Product Change Notice (PCN)

Subject: Change of assembly and test sites for Renesas EEPROM TSSOP Halogen-Free products

Appendix for 22-0007A

内装箱 Inner box

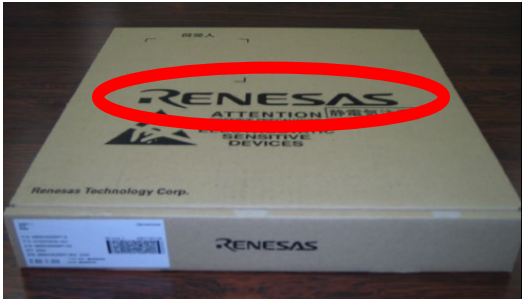
(Pre change:ATP product)

ルネサスロゴなし There is no logo mark of RENESAS

(Post change:MVC product)

ルネサスロゴ有 There is a logo mark of RENESAS

緩衝材 Cushioning material

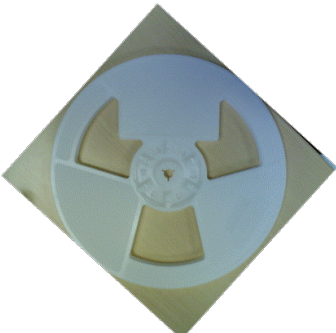
(Pre change:ATP product)

シールド袋、エアキャップあり
Shielding Bag with Bubble bag

(Post change:MVC product)

なし None

リールの色 Reel's color

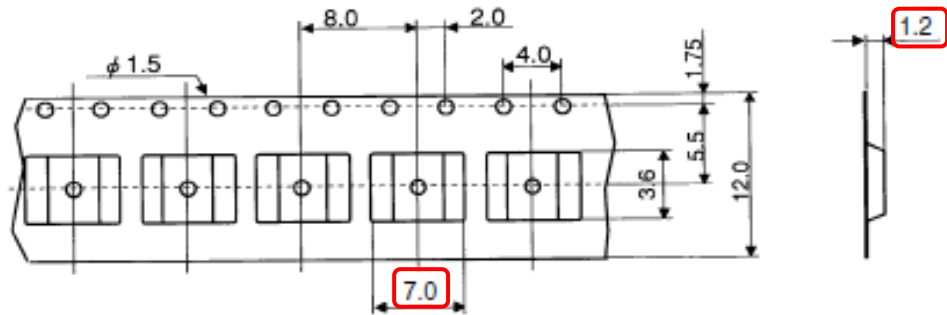
(Pre change:ATP product)

白 White

(Post change:MVC product)

黒 Black

エンボステープ仕様 Embossed tape dimensions (TSSOP-8)

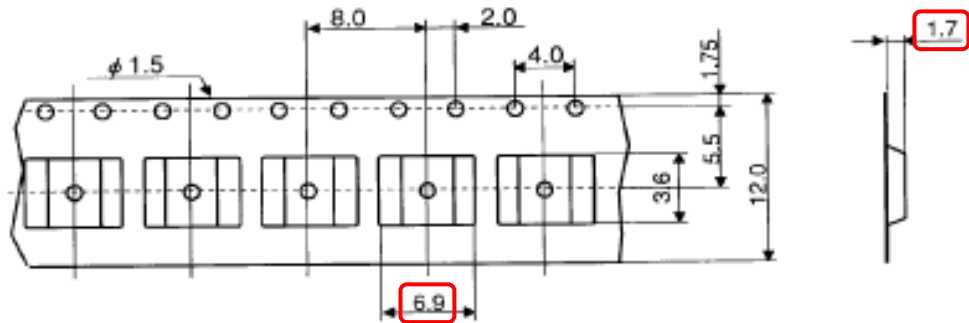
(Pre change:ATP product)

型名 (Tape type)	ADVANTEK TSSOP8
材質 (Material)	ポリスチレン (PS)
表面抵抗値 (Surface resistance value)	$1 \times 10^5 \Omega / \square$ 以下 $1 \times 10^5 \Omega / \square$ or less

パッケージコード (Package code)	TTP-8DAV
収納数 (storage No.)	A 3000 IC/内装箱 3000 IC/Inner box

(Post change:MVC product)

型名 (Tape type)	TE1208-7P
材質 (Material)	ポリスチレン (PS)
表面抵抗値 (Surface resistance value)	$1 \times 10^7 \Omega / \square$ 以下 (less than $1 \times 10^7 \Omega / \square$)

パッケージコード (Package code)	TTP-8DA TTP-8DAV
収納数 (storage No.)	3000IC/内装箱 (3000IC/Inner box)

リール仕様 Reel dimensions (TSSOP-8)

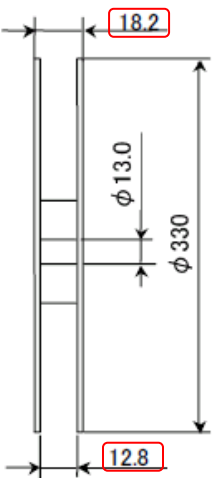
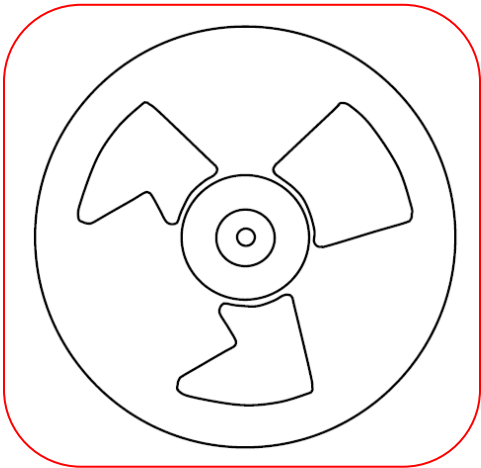
(Pre change:ATP product)

リール (Reel)	φ 330 プラスチックリール (12mm 幅用) φ 330 Plastic reel (for 12mm width)
材 質 (Material)	ポリスチレン (PS)
表面抵抗値 (Surface resistance value)	1 × 10 ⁹ Ω / □ 以下 1 × 10 ⁹ Ω / □ or less

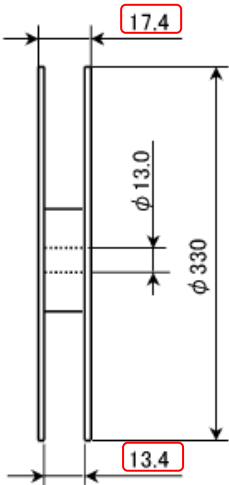
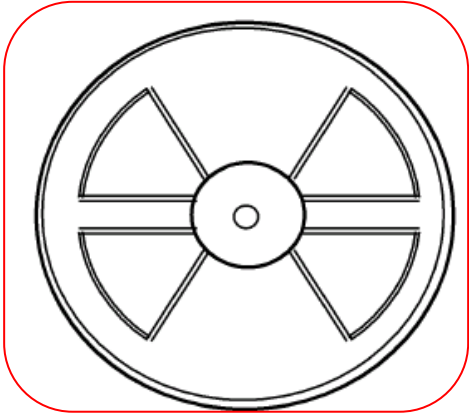
(Post change:MVC product)

リール (Reel)	φ 330プラスチックリール(12mm幅用) φ 330 plastic reel (For 12mm width)
材 質 (Material)	ポリスチレン (Polystyrene)
表面抵抗値 (Surface resistance value)	1 × 10 ⁹ Ω / □ 以下 (less than 1 × 10 ⁹ Ω / □)

4. Shipping label

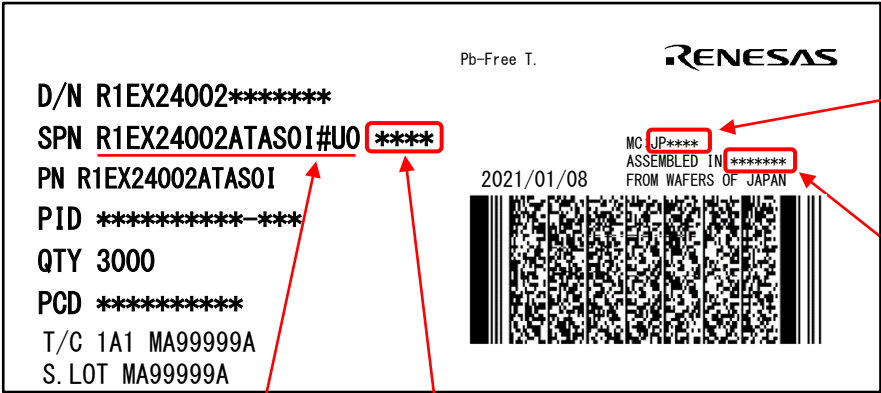
(Pre Change: ATP) : JPPHPH
(Post Change: MVC) : JPVNVN

(Pre Change: ATP) : PHILIPPINES
(Post Change: MVC) : VIETNAM

Orderable part name :
No Change

Internal code
(Pre Change: ATP) : ***D
(Post Change: MVC) : ***5
